ADDRESS: 2008 WALNUT ST

Proposal: Construct seven-story building along Chancellor Street

Review Requested: Final Approval

STAFF RECOMMENDATION: Denial, pursuant to Standard 9.

Proposed Front Elevation
(Chancellor St)

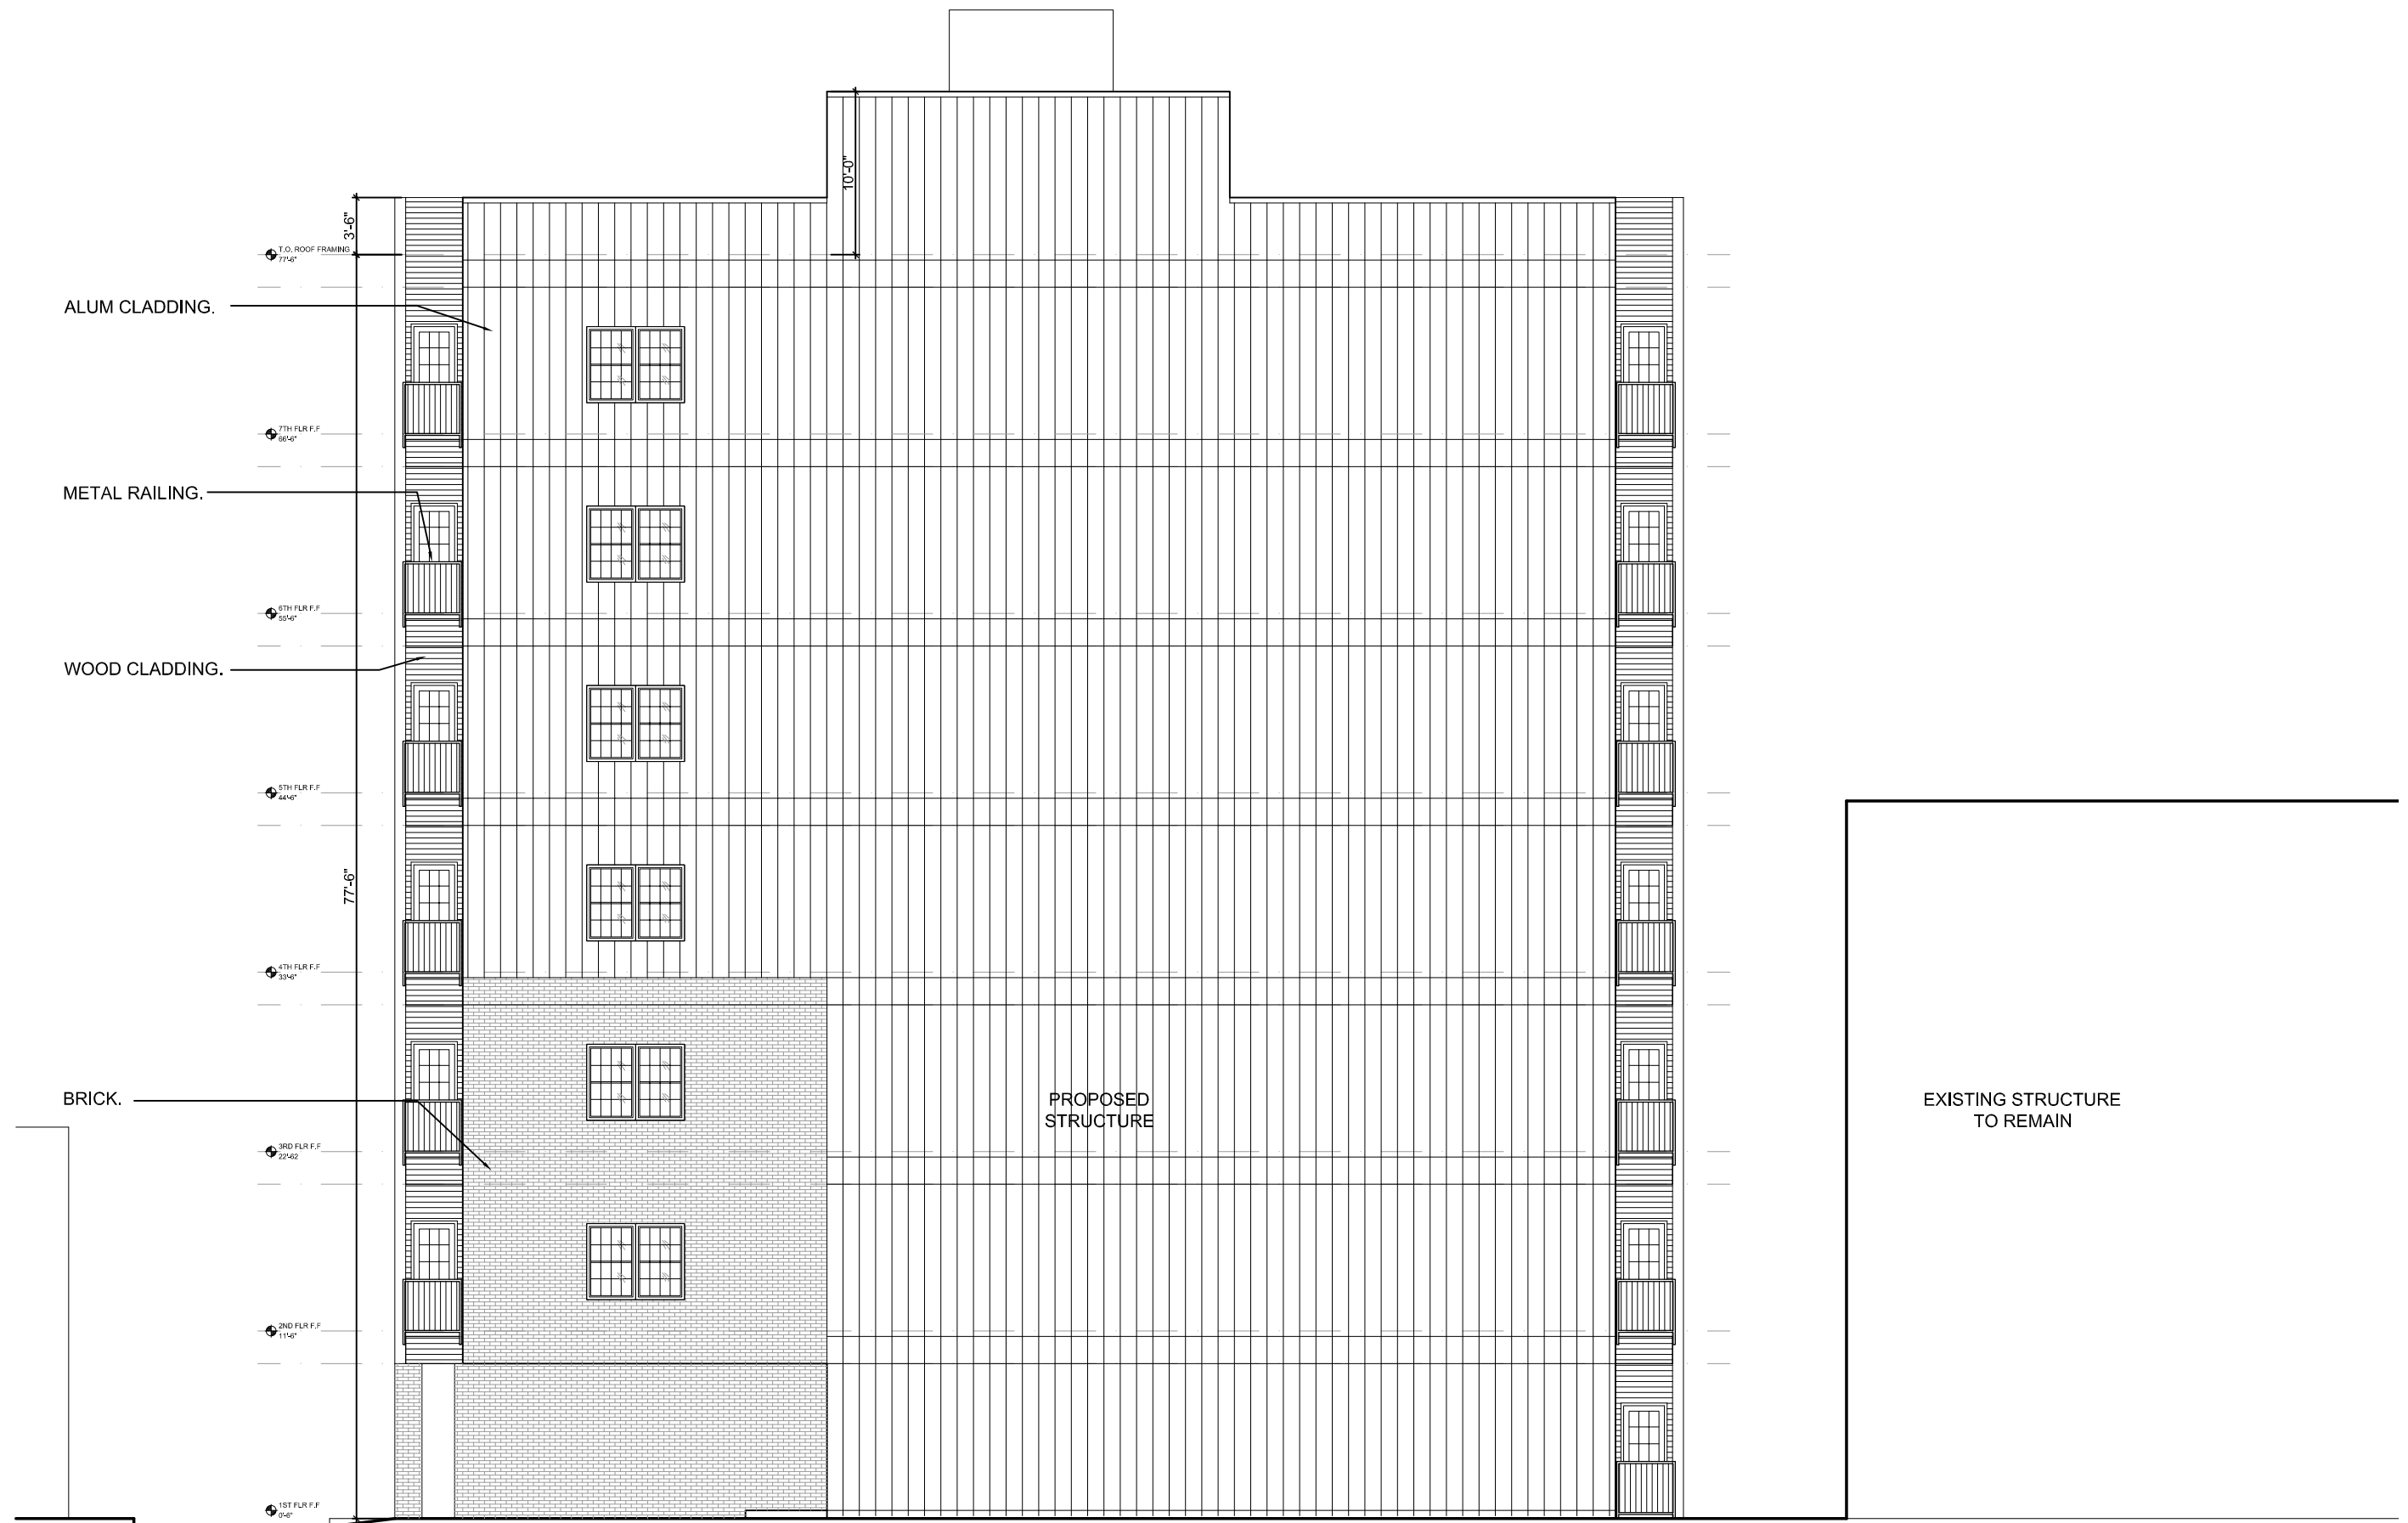
- Since Chancellor Street is primarily composed of low-scale buildings, the proposed new construction should be reduced in height or incorporate setbacks to meet Standard 9. Although the approved project at 2010 Walnut Street is seven floors, the top floor steps back to mitigate the appearance of height.

- Screen or enclose the first-floor parking area to satisfy Standard 9.
- *Standard 10: New additions and adjacent or related new construction will be undertaken in such a manner that, if removed in the future, the essential form and integrity of the historic property and its environment will be unimpaired.*
